REF: T631B A3

TITLE 631
BALANCED INPUT BUFFER

DRG. NO. T82330.71

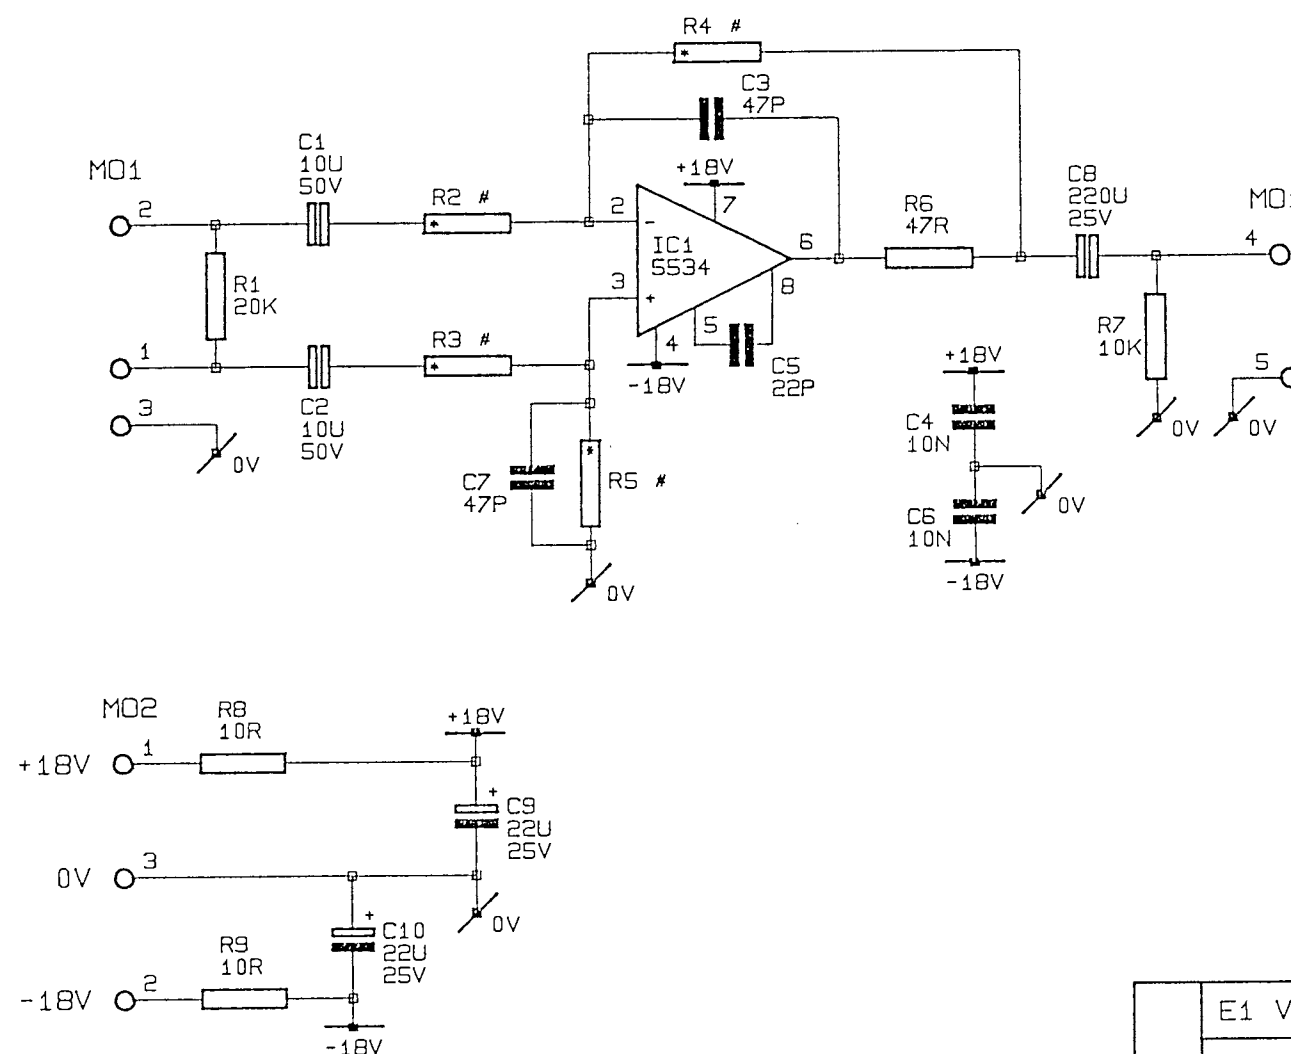
REV	ISSUE	DATE	DETAILS
0	A	20 FEB 90	NEW DRAWING RP STEFF
0	B	5 MAR 90	C1:2 WERE 100U 16V NOW 10U 50V. R2-4 WERE 8K2 & 13K0 NOW 19K1 & 30K1
